<b>Title of Change:</b>	FPF3188AUCX New Carrier Tape Design Qualification
<b>Effective date:</b>	19 Apr 2021
<b>Contact information:</b>	Contact your local ON Semiconductor Sales Office or <a href="mailto:Michelle.Lyn.Alaba@onsemi.com">Michelle.Lyn.Alaba@onsemi.com</a>
<b>Type of notification:</b>	This Product Bulletin is for notification purposes only. ON Semiconductor will proceed with implementation of this change upon publication of this Product Bulletin.
<b>Change Category:</b>	Assembly Change
<b>Change Sub-Category(s):</b>	Material Change

**Qualification of New Carrier Tape Design for FPF3188AUCX WLSCP Device**

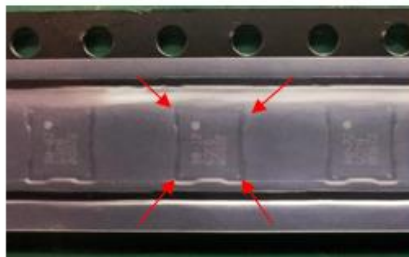
New carrier tape design with Corner relief for FPF3188AUCX WLSCP Device with changes comparison as below:

**FROM: No Corner Relief**

**TO: With Corner Relief**
